2005 Edition of ASCE 7
Minimum Design Loads for Buildings and Other Structures
Includes Supplement No. 1

Errata

Most recent errata posting: May 3, 2007
Third errata posting: October 3, 2006
Second errata posting: September 15, 2006
First errata posting: January 6, 2006

Chapter 6, Figure 6-18D, page 69 – two changes:

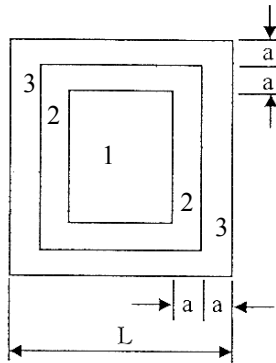
Change the title of Figure 6-18D from “Troughed Free Roofs” to “Free Roofs” as it applies to monosloped, pitched and troughed free roofs. Also, in the title block change “ $\lambda = 0^\circ, 180^\circ$ ” to read “ $\gamma = 90^\circ$.”

Revise Note 6 as shown below:

6. Notation:
L : horizontal dimension of roof, measured in the along wind direction, ft. (m)
h : mean roof height, ft. (m). [See Figures 6-18A, B or C for a graphical depiction of this dimension.](#)
 γ : direction of wind, degrees
 θ : angle of plane of roof from horizontal, degrees

Chapter 10 – Figure 10-1, page 102:

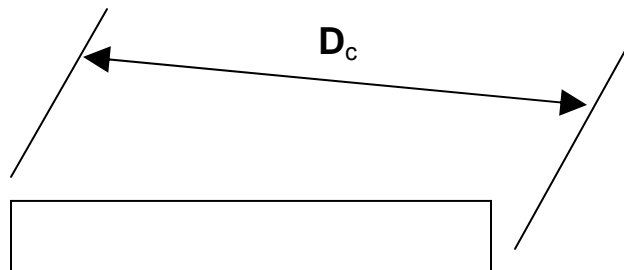
The dimension D_c in the upper right-hand diagram is measured from the upper corner of the rectangle on the left side to the lower corner on the right side as shown below:
